Access Compliance Report

Public Rights-of-Way

(Curb Ramps)

Intersection ID: 26458	Main Street: BRECHIN_DR	Cross Street: BROADFORD_CT	Location: SW
ADA ID: 650C375888DA	Ramp Type: Perpendicular	Initial Pass/Fail: Fail	Overall Compliance: No
Severity Score: 12.5			
Codes/Mitigation Info/Possible Solution		Field Measurements/Component Compliance

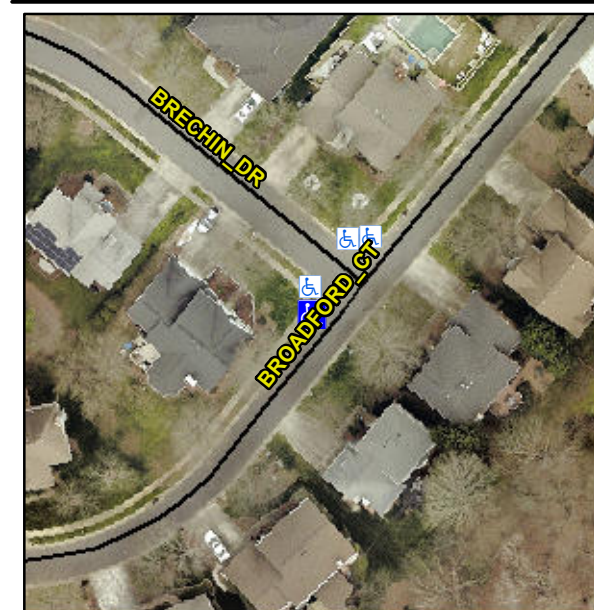
R304.2.2

Compliance	Description	Data	Compliance	Description	Data
N/A	Ramp Length (in)	45.0	No	Ramp Slope (%)	10.0
Yes	Ramp Width (in)	60.0	Yes	Ramp XSlope (%)	1.1
N/A	Flare Type LT	N/A	N/A	Flare Type RT	N/A
N/A	Flare Slope LT (%)	N/A	N/A	Flare Slope RT (%)	N/A
N/A	Flare Traversable LT?	N/A	N/A	Flare Traversable RT?	N/A
N/A	Landing Length (in)	N/A	N/A	DWS Provided?	N/A
N/A	Landing Width (in)	N/A	N/A	DWS Contrast?	N/A
N/A	Landing Slope (%)	N/A	N/A	DWS Length (in)	N/A
N/A	Landing X Slope (%)	N/A	N/A	DWS Full Width?	N/A
N/A	Landing Curb? (Y/N)	N/A	N/A	DWS Offset (in)	N/A
N/A	Shared Landing?	N/A			
N/A	Gutter Ponding?	N/A	N/A	Gutter Slope (%)	N/A
N/A	Gutter Lip Ht (in)	N/A	N/A	Gutter X Slope (%)	N/A
N/A	Painted X Walk1?	No	N/A	Painted X Walk2?	N/A
	X Walk 1 Direction	To SE		X Walk 2 Direction	N/A
N/A	X Walk 1 Width (in)	N/A	N/A	X Walk 2 Width (in)	N/A
	X Walk 1 Slope (%)	1.4		X Walk 2 Slope (%)	N/A
	X Walk 1 X Slope (%)	2.1		X Walk 2 X Slope (%)	N/A

Remove & Replace Entire Ramp.
